## TECHNICAL BULLETIN

# COMPAIR COMPRESSORS SAFETY IMPROVEMENT

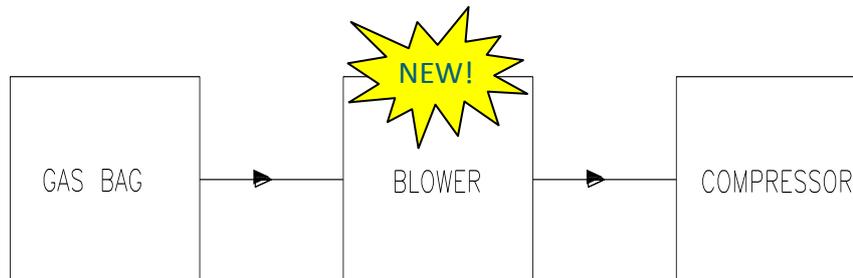
THE IMPROVEMENT IS INTENDED FOR EXISTING EQUIPMENT AND CAN BE PROPOSED IN TWO DIFFERENT MANNERS:

1. SUPPLY OF THE MAIN ITEMS AND ARRANGEMENT DESCRIPTION.  
(INSTALLATION NOT DRASS SCOPE OF SUPPLY)
2. VISIT ON BOARD TO CHECK THE STATUS OF THE EQUIPMENT INSTALLED, DETAILED INSTALLATION ENGINEERING INCLUDING SUPPLY OF MATERIALS TO APPLY THE PROCEDURE.

### BLOWER PERFORMANCE CURVE

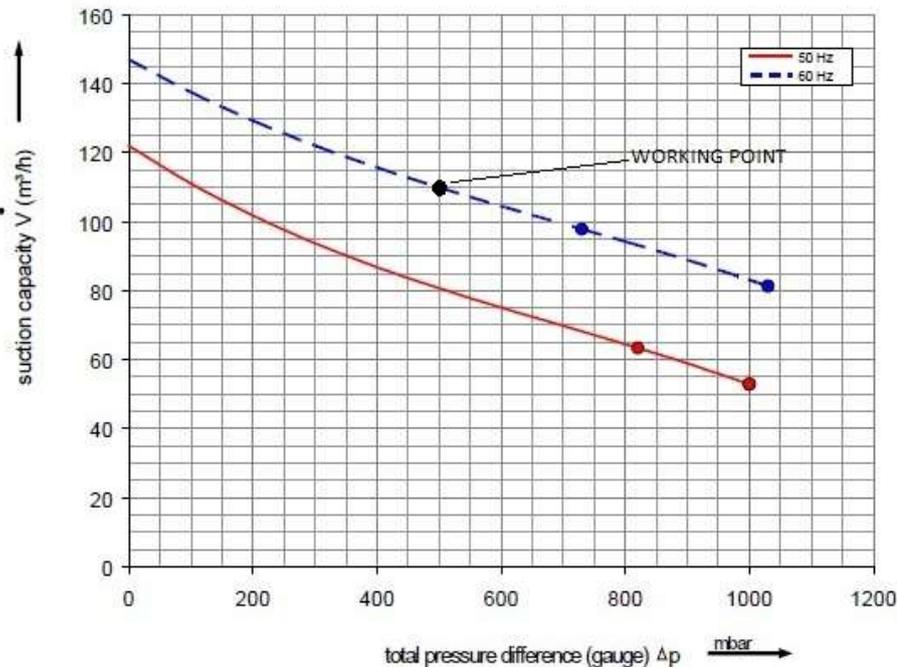
AT THE COMPRESSOR'S NORMAL FLOW (APPROX. 110M<sup>3</sup>/H) THE BLOWER CAN PRODUCE A  $\Delta P = 500$  MBAR, THEREBY INCREASING THE VALUE OF THE COMPRESSOR'S INLET PRESSURE.

THE DISCHARGE PRESSURE OF THE BLOWER IS HOWEVER LOWER THAN THE COMPRESSOR'S MAXIMUM SUCTION PRESSURE.

THE INSERTION OF THE BLOWER PREVENTS THE COMPRESSOR FROM WORKING IN VACUUM AND MORE IMPORTANTLY, INCREASES FLOW CAPACITY.

IF THE BOOSTER AND THE COMPRESSOR ARE CONNECTED WITH A 1.1/4" LINE ( $\varnothing$  32MM), IN THE ABOVE WORKING CONDITIONS, THE PRESSURE DROP OF THE LINE IS 200MBAR EVERY 100MT. AS A CONSEQUENCE, THE MAXIMUM

DISTANCE BETWEEN THE BLOWER AND THE COMPRESSOR FOR CORRECT OPERATION CAN REACH 250M (EQUIVALENT DISTANCE, I.E. WITHOUT CURVES AND NARROWING). THIS ALSO ALLOWS THE GAS BAG TO BE POSITIONED FURTHER FROM THE COMPRESSOR, IN THE CASE THAT THIS IS REQUIRED. LONGER DISTANCES CAN BE REACHED, INCREASING THE SIZE OF THE LINE.

DESCRIPTION VACUUM SWITCH -5 TO -20 mBAR

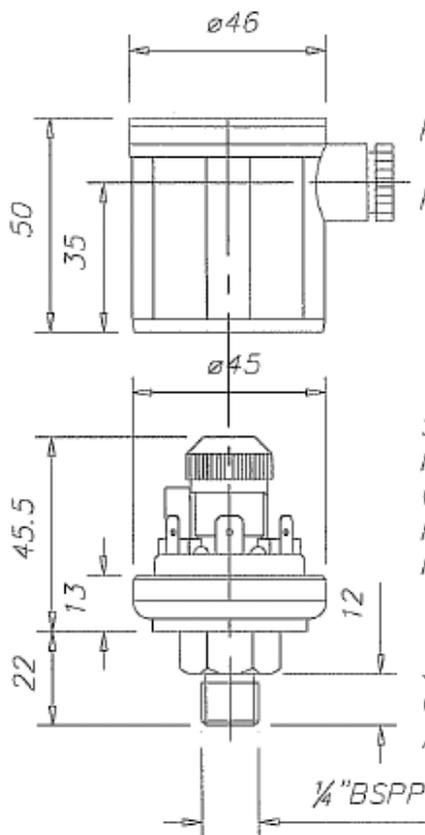
FOR EXAMPLE, DRASS NOTED THE WRONG INSTALLATION OF THE SAFETY VACUUM SWITCH ITEM BECK PRESCAL 901.71 INSTALLED ON COMPAIR 5437 COMPRESSORS, ON THE SUCTION SIDE.

THE SWITCH SHOULD BE INSTALLED ON TERMINALS 3-2, NORMALLY CLOSED, INSTEAD OF BEING INSTALLED ON 3-2 NORMALLY OPEN. ACCORDING TO THE FOLLOWING DATASHEET, IN ORDER TO AVOID AN INCORRECT WORKING STATUS WHEN THE PRESSURE FALLS UNDER -20 MBAR.

WHEN CHECKED WITH A METER THE SWITCH CONNECTIONS SHOULD BE 'CLOSED' UNLESS A VACUUM IS APPLIED OPENING THE CONTACTS. THIS CAN BE FOUND IN THE WIRING SCHEMATICS PROVIDED WITH COMPRESSOR MANUALS.

TO ENSURE GOOD OPERATION, THE CONTROL LOGIC INSIDE THE PANEL OF THE COMPRESSOR SHALL BE MODIFIED IN ORDER TO MATCH THE CORRECT SWITCH SETTINGS AND THEREFORE TO GUARANTEE THE COMPRESSOR'S SAFE STOPPING FUNCTION.
